October 31, 1985  
ST-HL-AE-1491  
File No.: G9.17

South Texas Project  
Units 1 and 2  
Docket Nos. STN 50-498, STN 50-499  
Responses to DSER/FSAR Items on Chapter 10

Question 282.01N

FIGURE 1

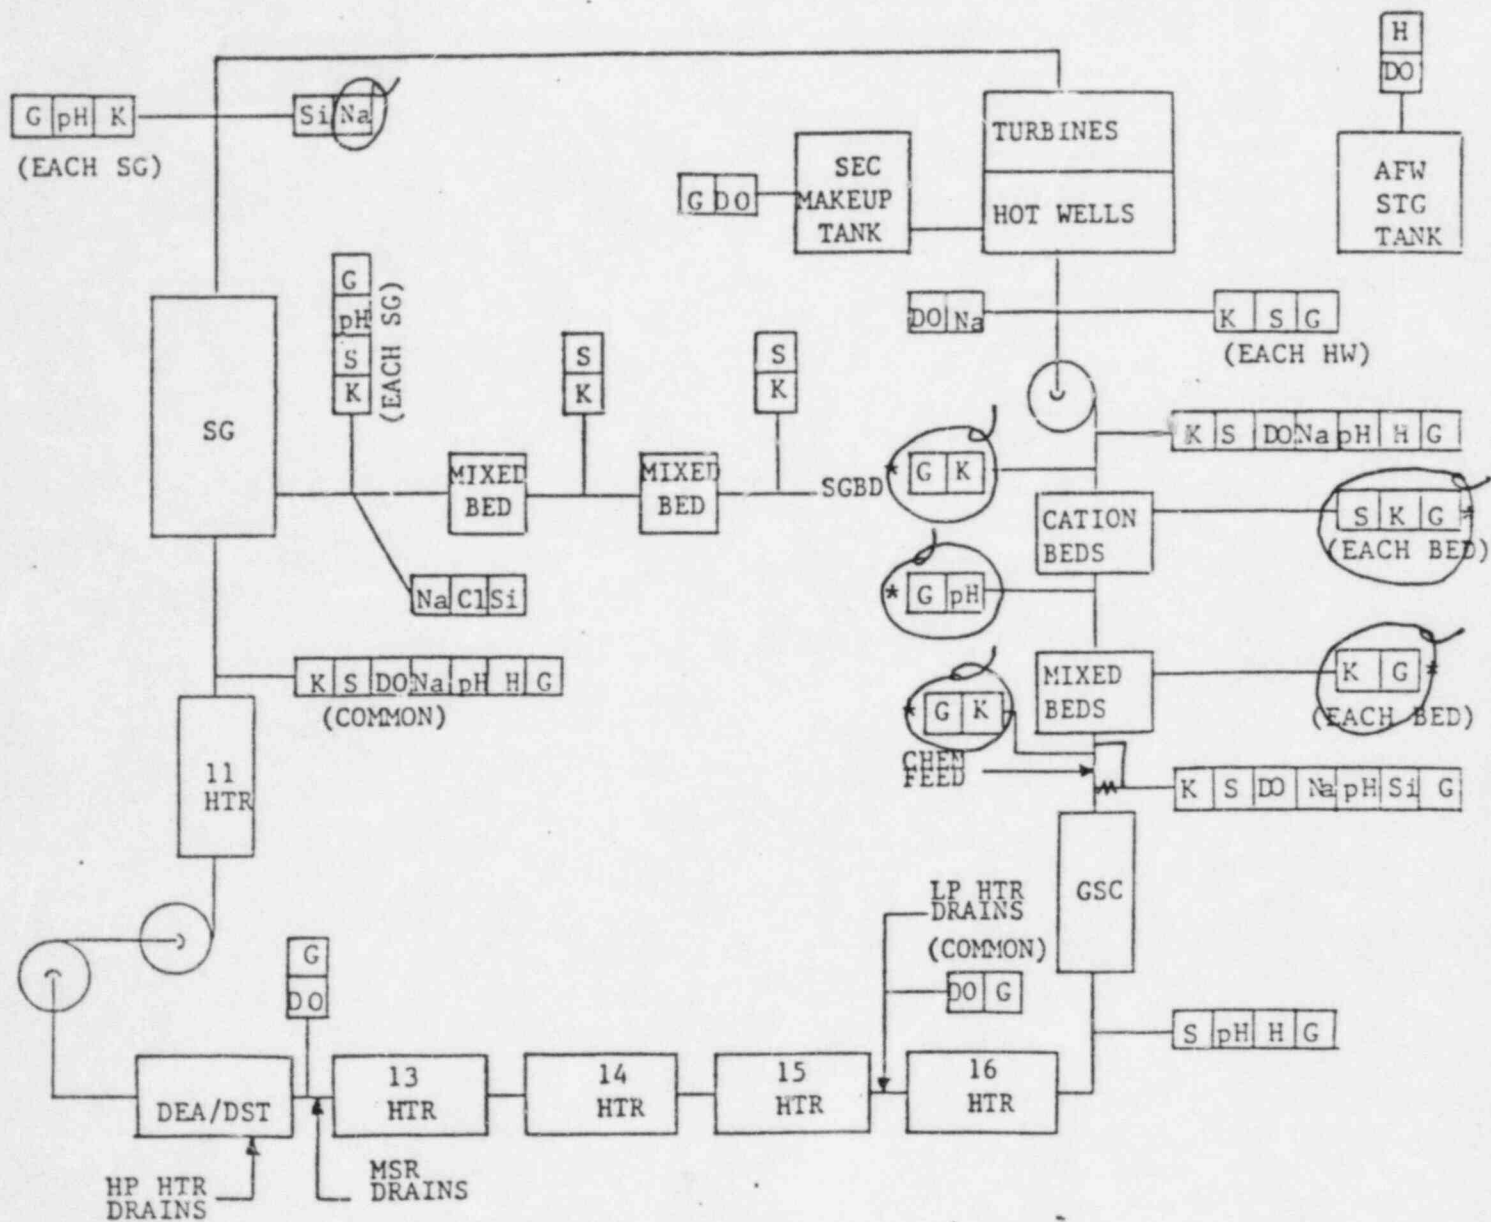
Provide a summary of operative instructions to be used for the steam generator secondary water chemistry control and monitoring program, addressing the following:

1. Sampling frequency for the critical chemical and other parameters and of control points or limits for these parameters for each mode of operation: normal operation, hot startup, cold startup, hot shutdown, cold wet layup;
2. Procedures used to measure the values of the critical parameters;
3. Location of process sampling points;
4. Instructions for the recording and management of data;
5. The program element defining corrective actions for off-control point chemistry conditions detailing time allowed at off-chemistry conditions.

3. The location of the secondary sampling points are shown in Figure 1.
4. Analytical results are recorded on the appropriate Worksheet, Log Sheet, Data Sheet, or other approved form. Key plant chemistry data is transferred to daily chemistry reports as well as plotted graphically to show abnormal trends of parameters.
